# SKEP III Home Office Support Site Visit Report

Consultant	Wahib Medanat Consultant Engineer	Rep No.	12-11042022
Contractor	Derar Saraireh & Sons for Engineering & Contracting	Tender No.	(11/2019/USAID/SKEP/3/S) Schools for a Knowledge Economy Project (SKEP) - Phase (3) Package (1, 2)
Site Name	Al Khansa' Basic Mixed School- Al Balqa	Day/ Date	Mon. 11/04/2022
Duration of Project	450 Calendar Days	Total Project Budget	9,789,417.840 JD

(Figure: 17)

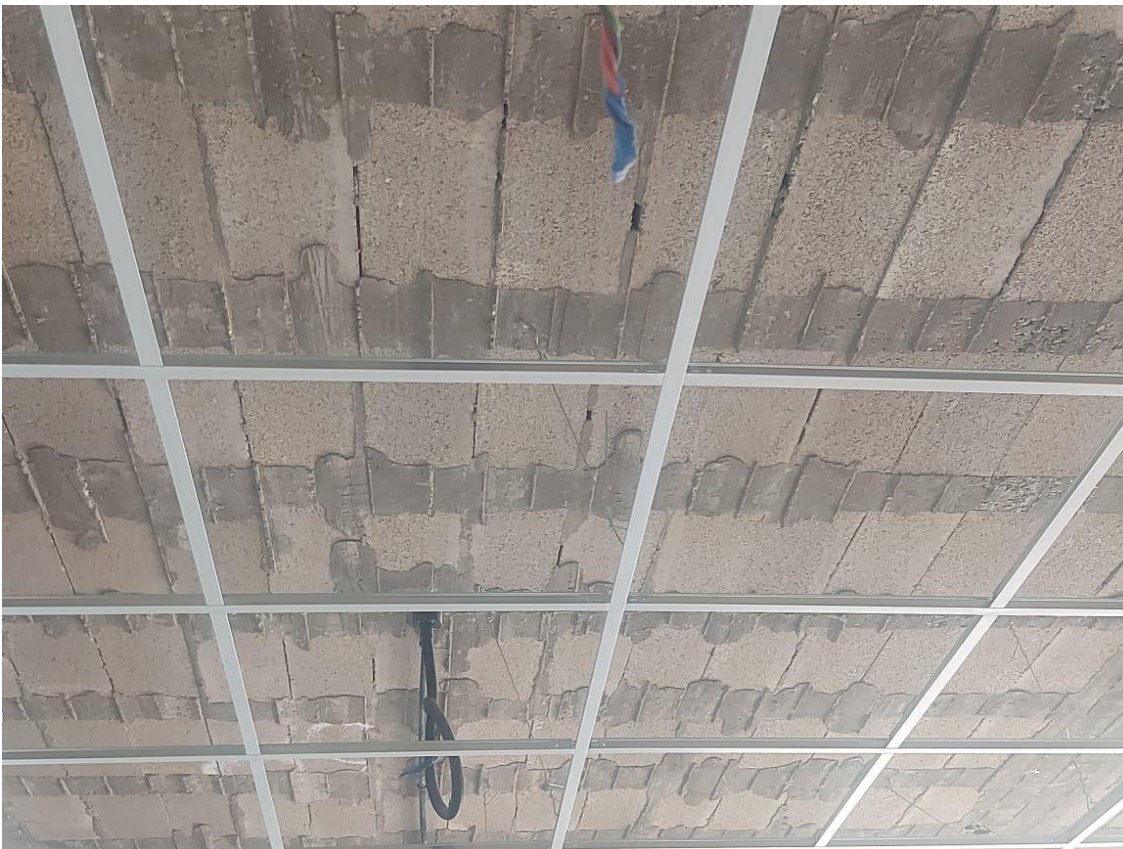
The team observed the gap between the edge of extinguisher cabinets and the plastering wall and discussed with the Contractor some suggestions of the appropriate solutions
